From: Arch P [arch@sunflower.com]
Sent: Tuesday, February 12, 2013 6:43 AM
To: schummfoods@gmail.com; mdever@sunflower.com; hughcarter@sunflower.com; aroncromwell@gmail.com; mikeamyx515@hotmail.com; Bobbie Walthall
Subject: Retirement village and Langston heights lc

Subject: RE: Langston Heights Addition - revised Concept Plan

RE: Langston Heights Addition
Planning Commission Agenda Items on December 10, 2012

RE: Langston Heights Addition
Additional Correspondence for
Planning Commission Agenda Items on December 10, 2012

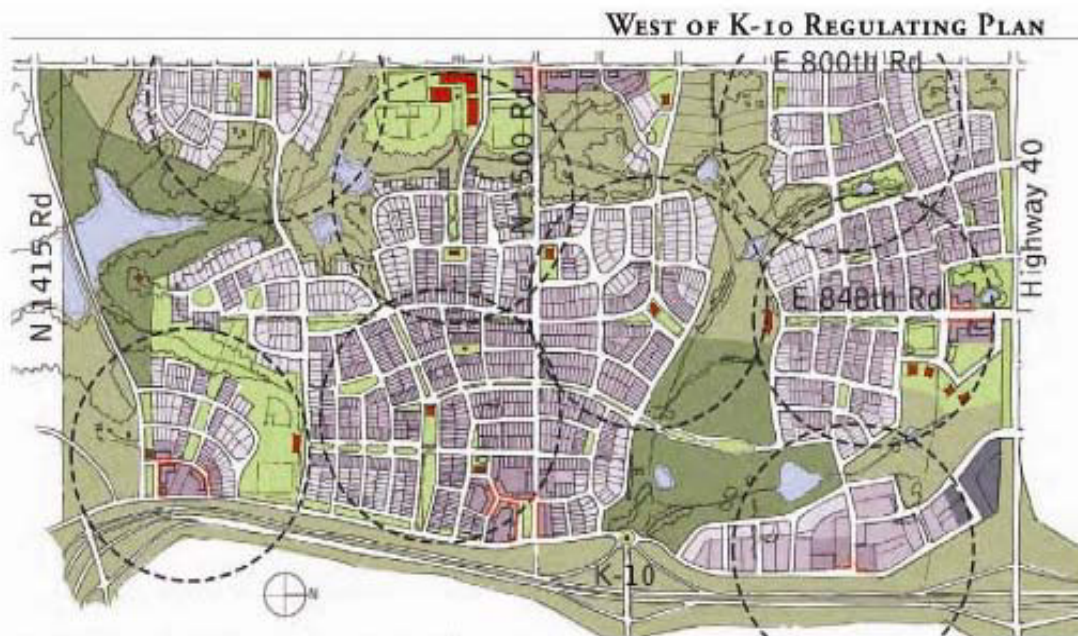
2. The Nodal plan specifically addresses the Diamondhead and Langston Heights area. The nodal plan indicates that "this intersection is envisioned as a multiple-use activity center of low-, medium-, and high-density residential development; commercial, office, research, and industrial activities; public, semi-public, and institutional uses; and parks, recreational, and green/open space opportunities." It further states for the Southeast Corner, that the corner provides an opportunity for a variety of residential, commercial, and office activities. This nodal plan "also designates the majority of its residential uses appropriate for low-

density, single-family neighborhoods with a **small** portion considered appropriate for medium-density residential development. This medium-density development serves as primary buffer between single-family neighborhoods and commercial activities.” It further states that “This nodal plan anticipates more low-density, single-family residential development in the areas surrounding this corner and therefore much of this corner was designated appropriate for similar development to maintain compatibility of surrounding land uses.” The staff report quotes specific sections but fails to address the statement “appropriate for low-density, single-family neighborhoods.” It only constantly quotes “a mixture of housing types... should be encouraged.” We do not dispute the need for a mixture of housing types, but the question is whether this proposal is the correct mixture or the correct location? The developer and applicant admitted at the neighborhood meeting that this type and mix of development “has not been tried or developed in Lawrence.” Why is this established successful neighborhood the place to try this experiment?

Figure E - Pre-determined zoning plan

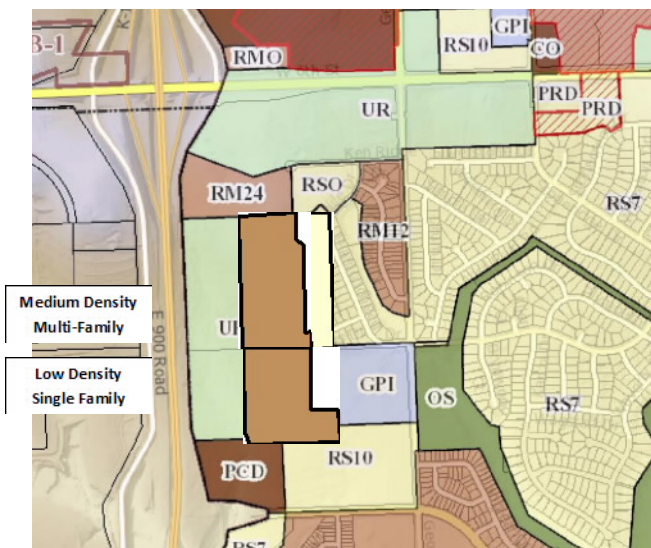
The map at left indicates the pre-determined extent of the southern land and, the quantity of medium density zoning, is counter to the current adopted land use documents.

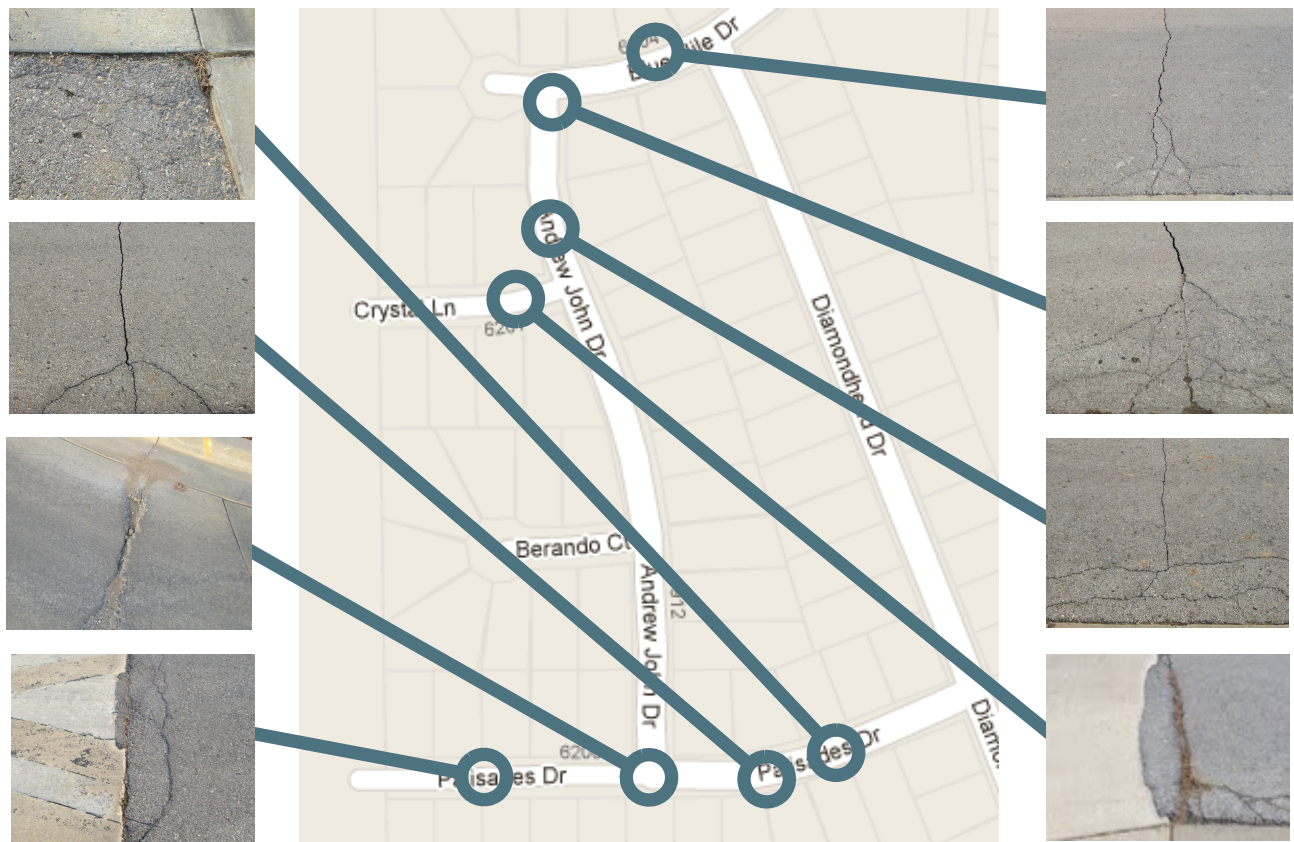
None of the intersections in the community feature traffic signage. The applicants count at least 138 additional trips per hour with the traffic study, but fail to demonstrate its effect within the existing layout. We have already discussed the potential for pedestrian accidents, but the limited sight-lines and lack of any stop or yield signs is an invitation to traffic accidents.
